MEMORANDUM

DATE January 3, 2022 PROJECT 16252A.77
NUMBER
TO Danielle Condit, Associate Planner PROJECT 526 Waverley Street, Palo Alto
Danielle.Condit@CityofPaloAlto.org
OF City of Palo Alto Planning & FROM Hannah Simonson,
Community Environment Dept. Cultural Resources Planner
250 Hamilton Avenue, 5th Fl Christina Dikas, Associate Principal,
Palo Alto, CA 94301 Project Manager
Ruth Todd, Principal-in-Charge
CC Amy French, VIA Email
Amy.French@cityofpaloalto.org
REGARDING 526 Waverley Street, Palo Alto – *Secretary of the Interior's Standards for Rehabilitation*
Compliance Analysis

TENANT REMODEL & INTERIOR IMPROVEMENT
526 Waverley St.
Palo Alto, CA 94301

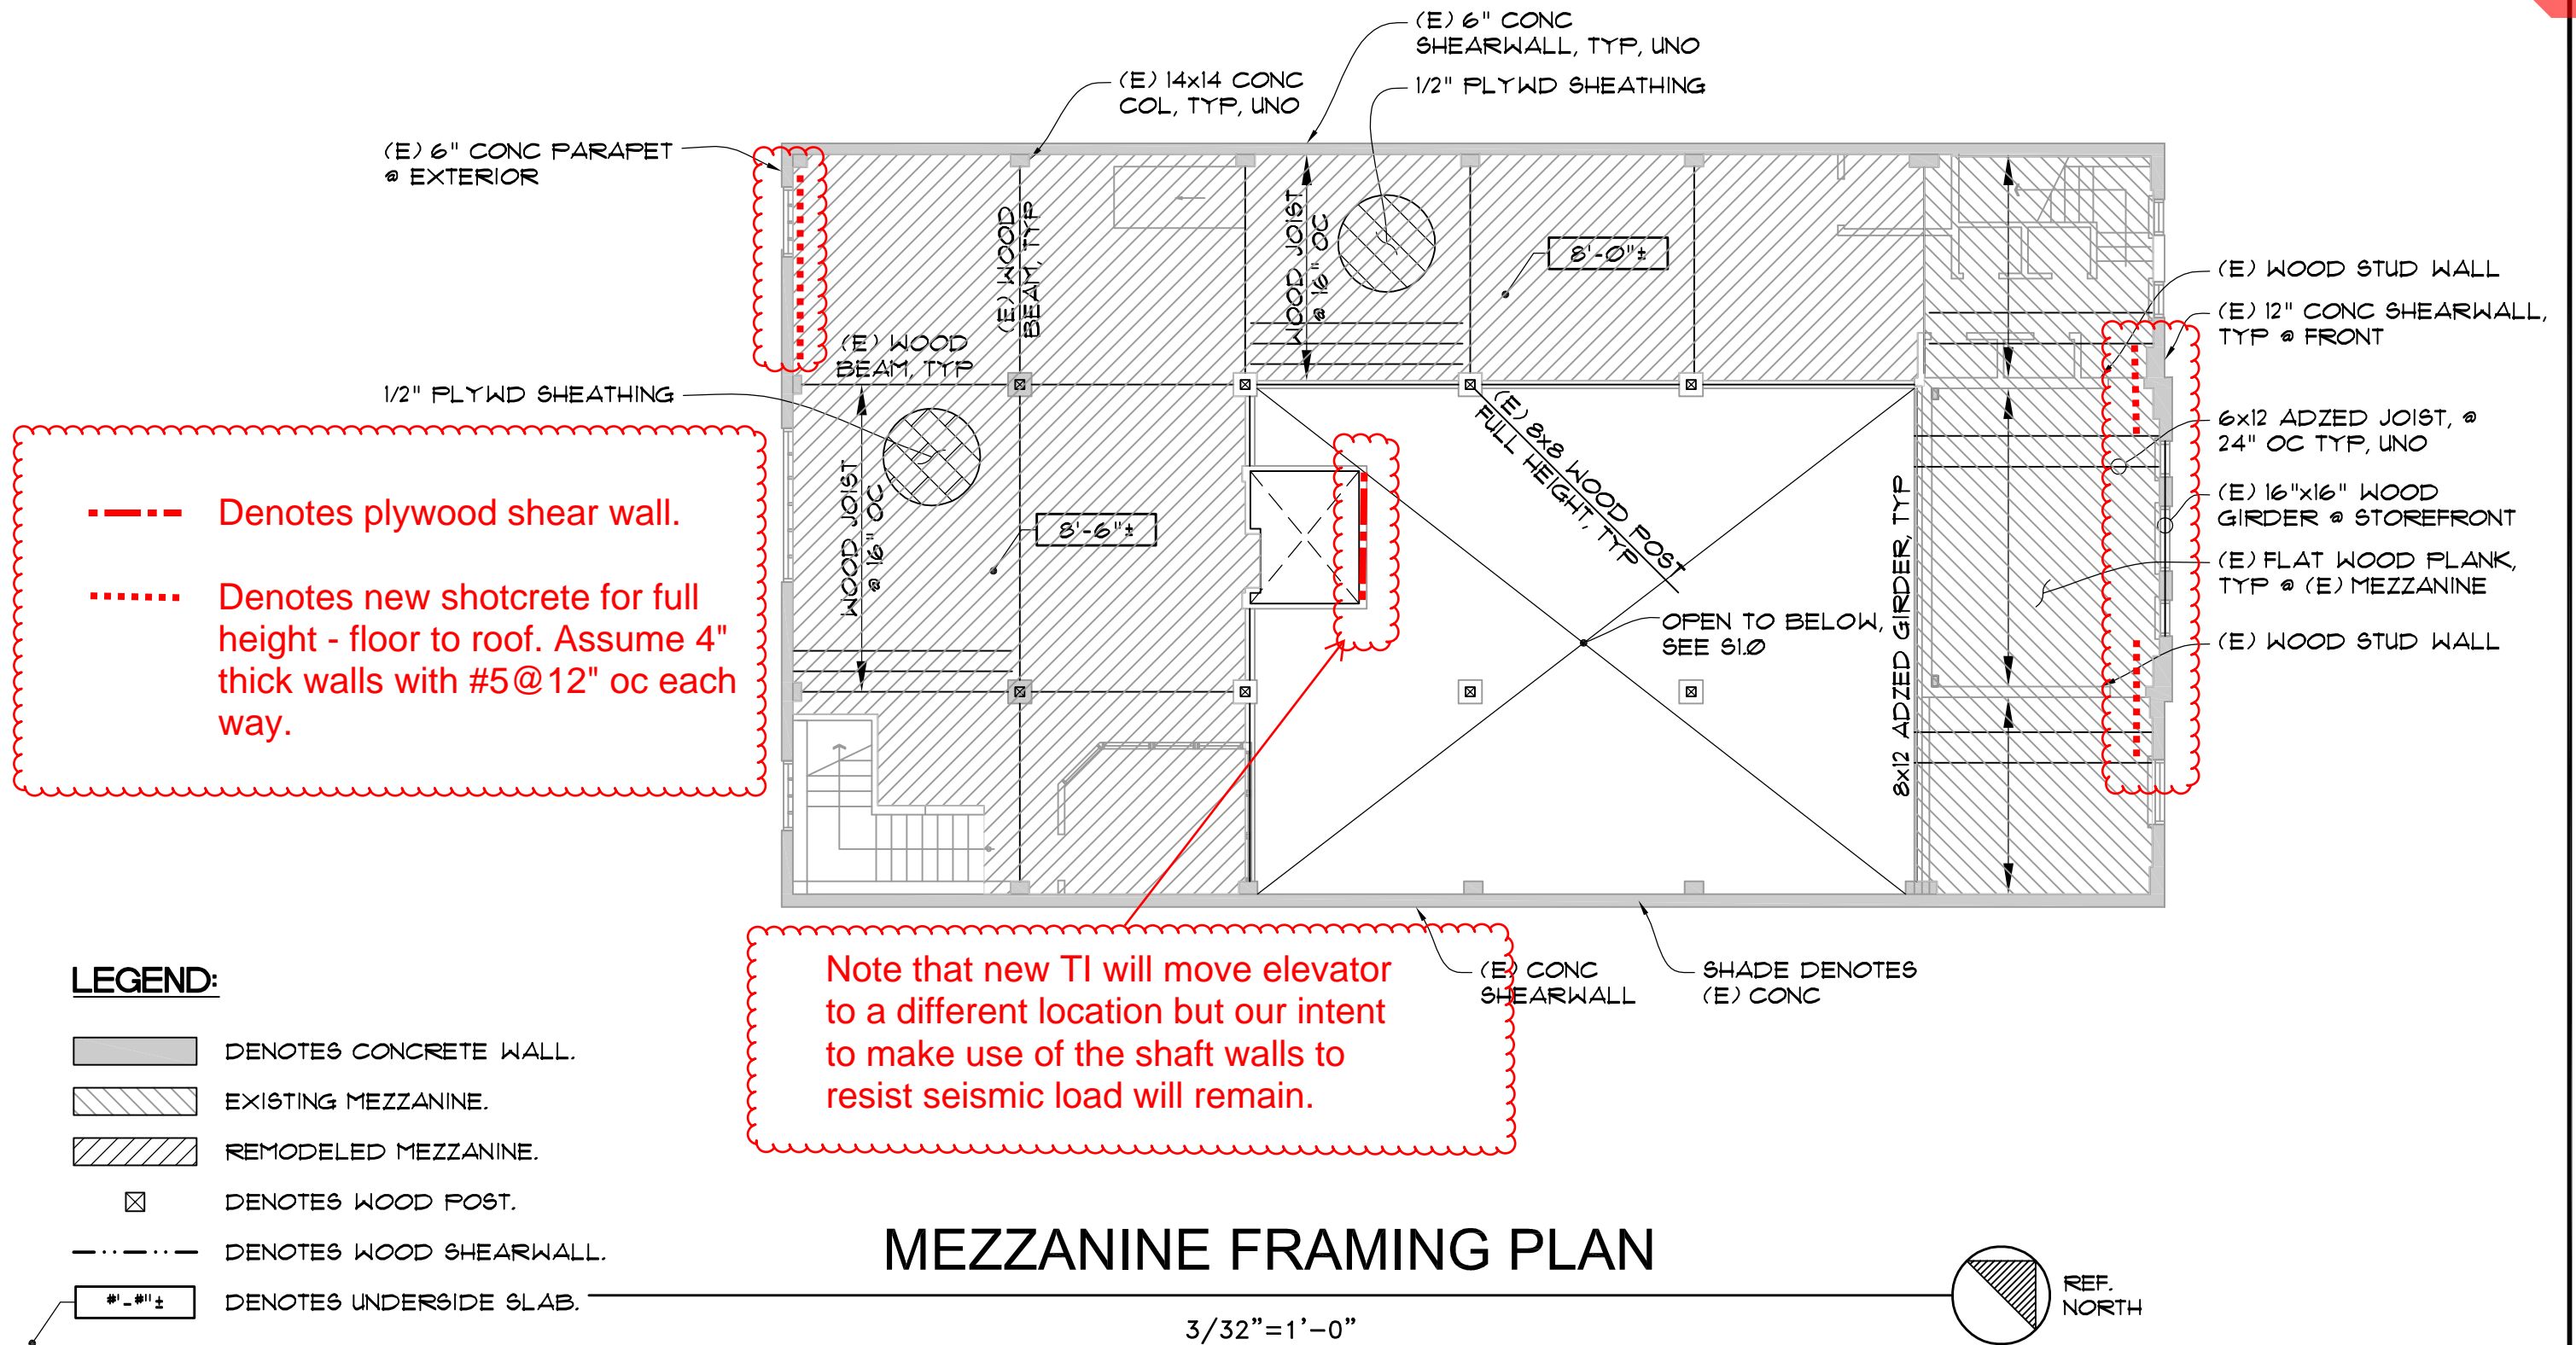
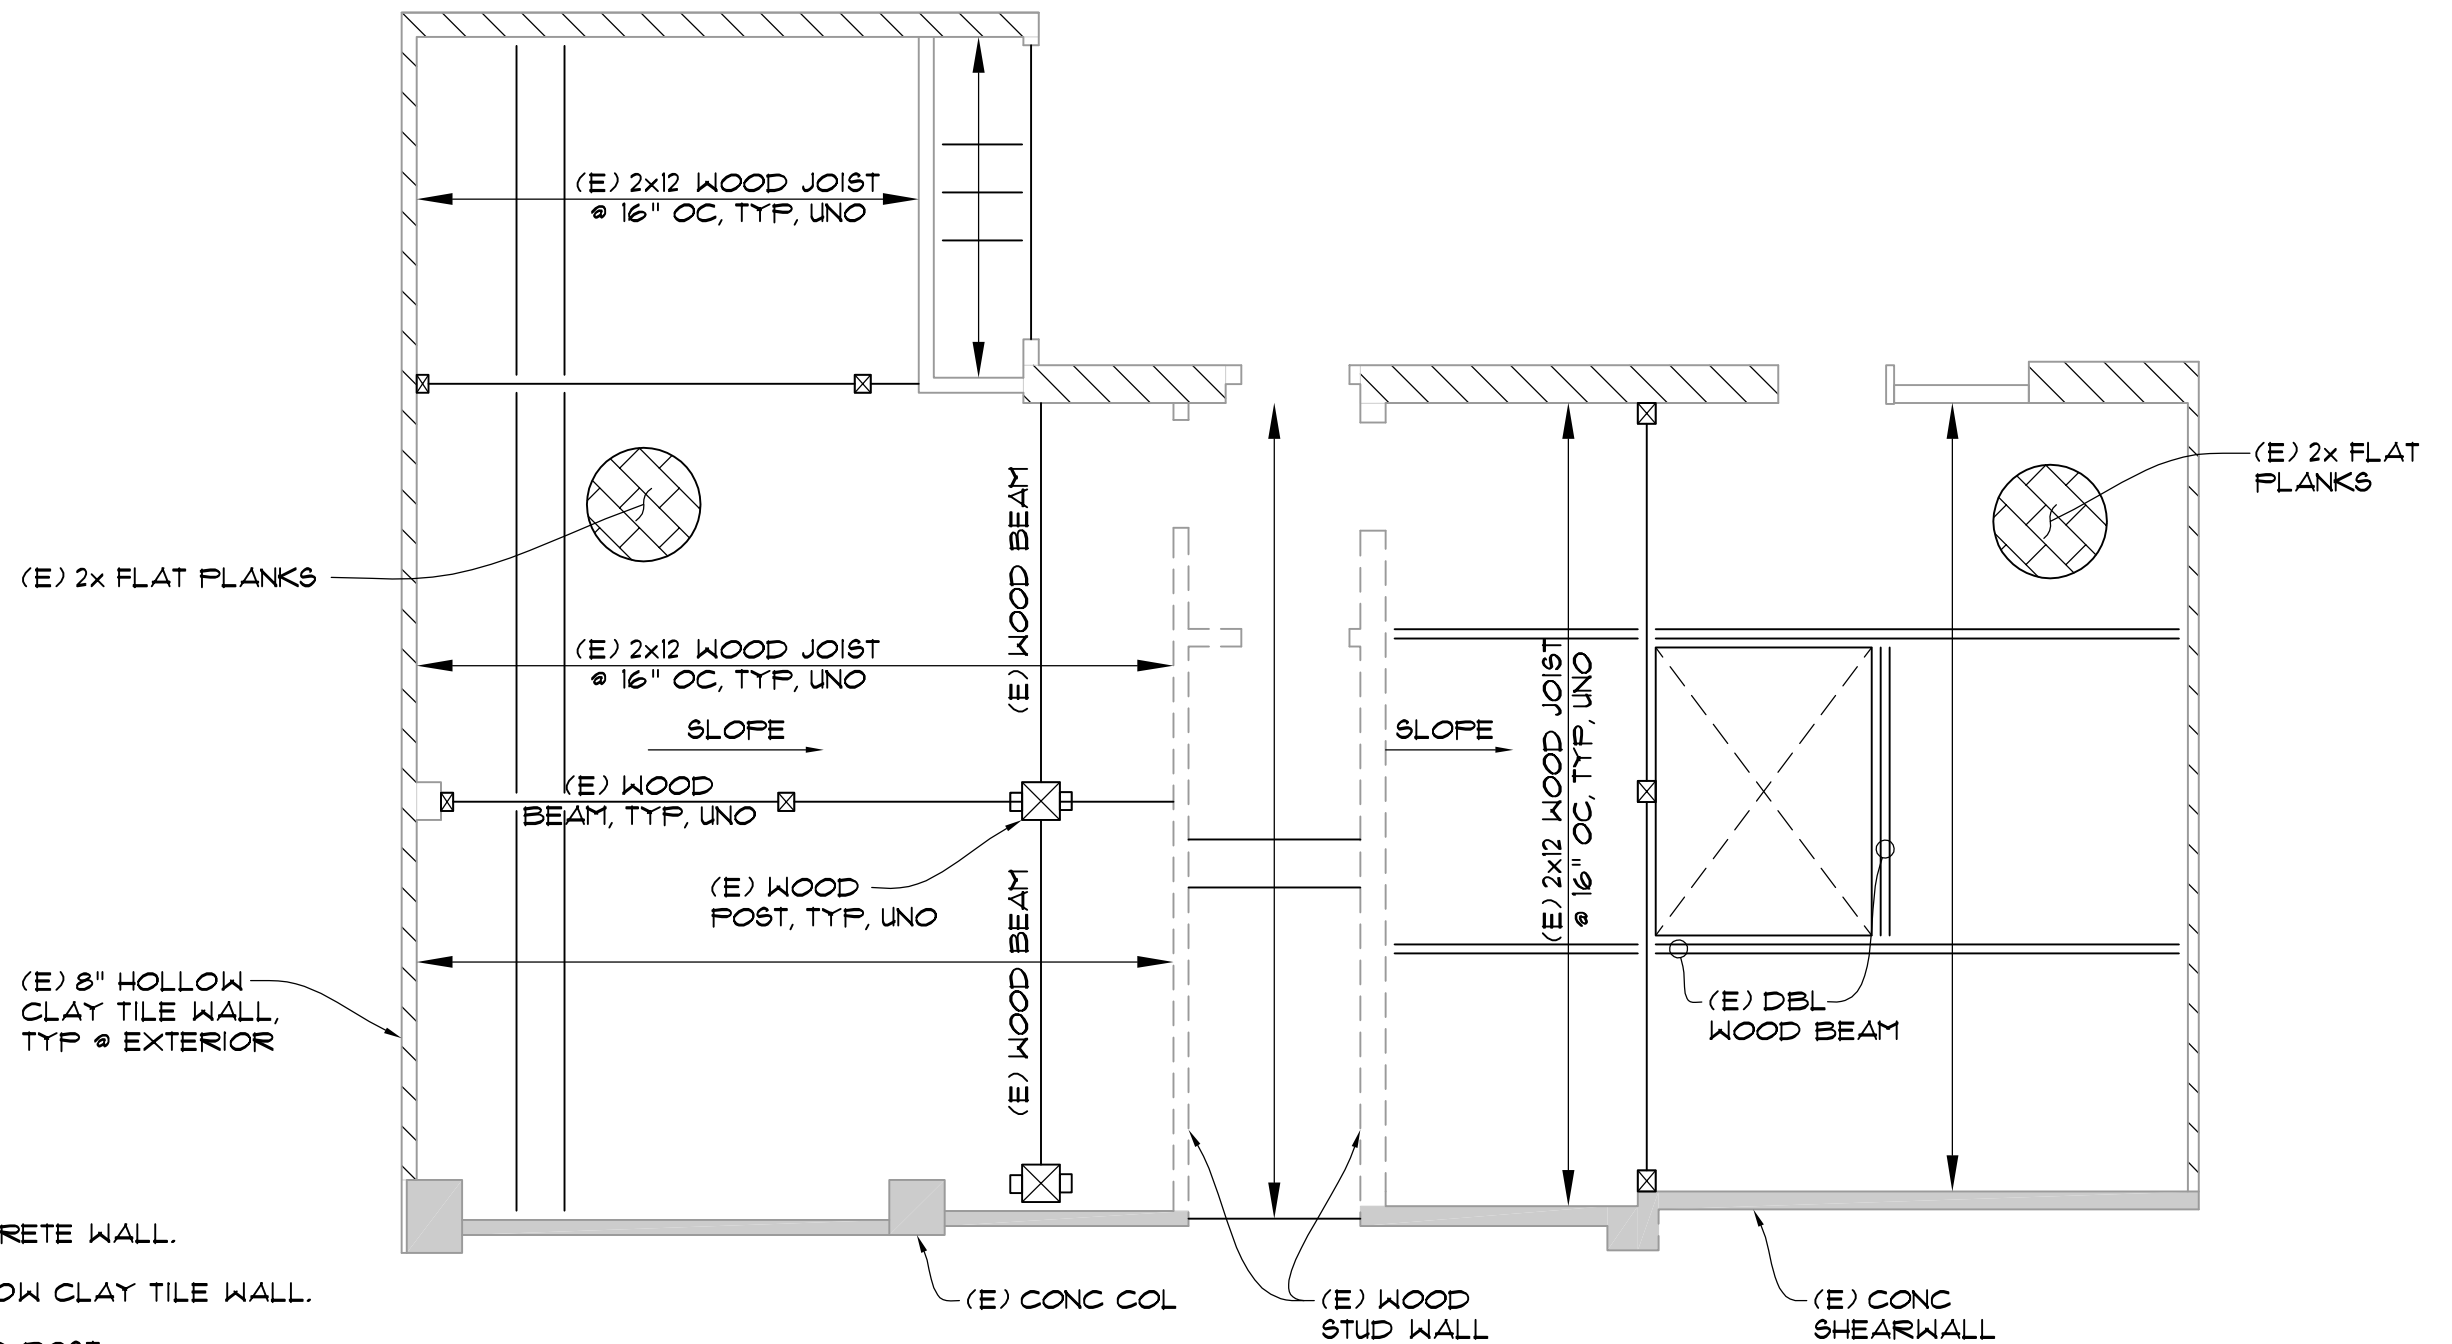
The proposed project also includes a seismic upgrade, which was described conceptually to Page & Turnbull in a marked-up diagram titled "Tenant Remodel & Interior Improvement: 526 Waverly St" (sheet dated May 3, 2018, updated December 9, 2021) by Sierra Engineering Group (emailed to Page & Turnbull and Palo Alto planning staff on December 9, 2021), and in an email from the property owner, John R. Shenk, Thoit Bros., Inc. on December 15, 2021. The seismic work will include:

The structural engineer, via email from the property owner, confirmed that the seismic work "will not effect the existing window openings and they will remain as they exist currently" and that "There is no seismic work for the mezzanine framing so the beams in question will not be touched. Only those mezzanine areas being lowered as well as the new additional mezzanine floor area will require new sheathing."⁷

Note: Should the seismic upgrade approach change in the future, additional review may be needed.

Should the seismic upgrade approach change in the future, additional review may be needed.
